Item 20-15 Proposal to include new parking sign in the CA MUTCD

Requesting Agencies/Sponsor: Caltrans/Monica Kress-Wooster, CTCDC member

Figure 2B-24 (CA). Parking and Standing Signs and Plaques (R7 Series) (Sheet 1 of 3)

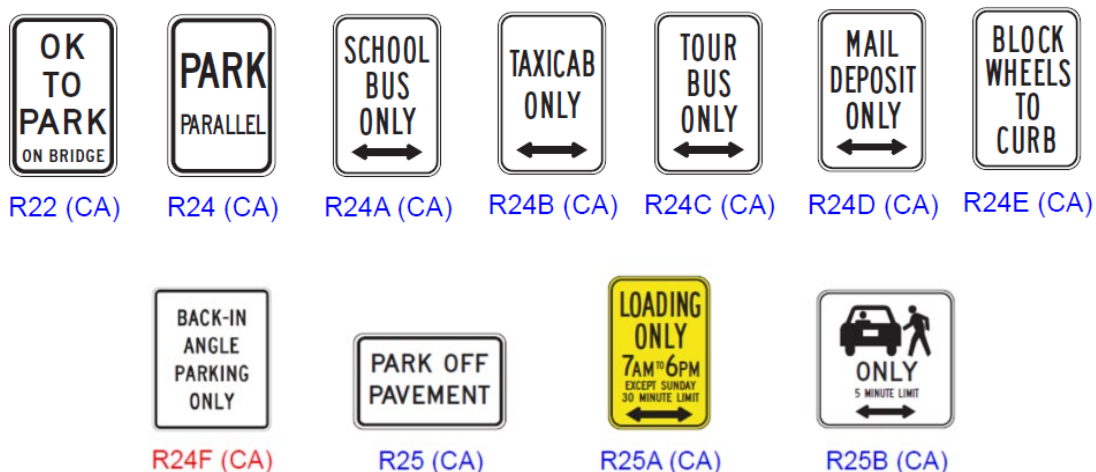
Proposal: The CA MUTCD does not have a sign to address back-in angle parking. Adding this proposed sign to CA MUTCD will support the diagonal parking stall markings. Back-in angle parking enhances the safety of the bicyclists sharing the road with vehicles parked in the direction of travel. Back-in angle parking also enhances the safety of the driver and passengers to enter or exit from vehicle.

^{14a} *If supported by local ordinance, the "BACK-IN ANGLE PARKING ONLY (R24F(CA)) sign should be used.*
